7000Acres

**7000Acres Response to the West Burton Solar Project Ltd Application –
National Policy Statements and Application of Planning requirements**

Deadline 1A Submission – 7th December 2023

Cottam and West Burton Phase 1 Consultation Leaflet (IGP, 2022)

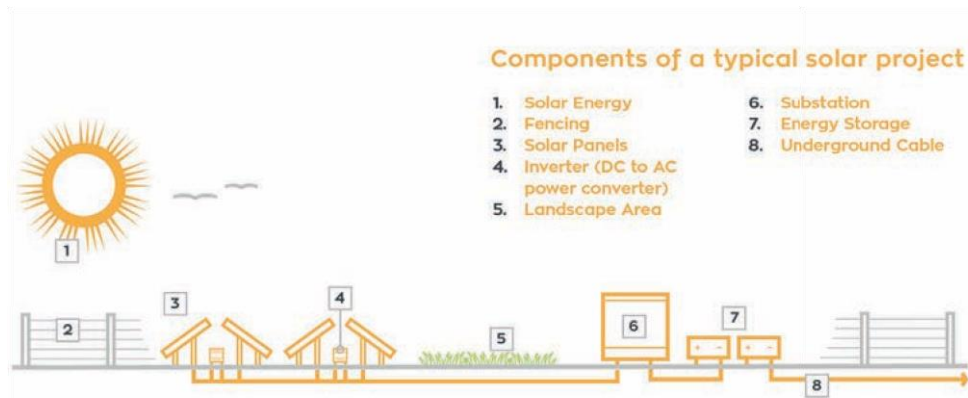
The diagram clearly shows the solar panels being no higher than the security fencing. This misleading impression was repeated in the Applicant’s Phase 2 consultation where “example” solar arrays were shown. In this case the Applicant shows an array that appears to be about 2 m high.

None of the material issued to the public or shown at the public consultation meetings showed the true height of the solar panels. Members of the public had to search the PEIR for the true height of the panels and other infrastructure.
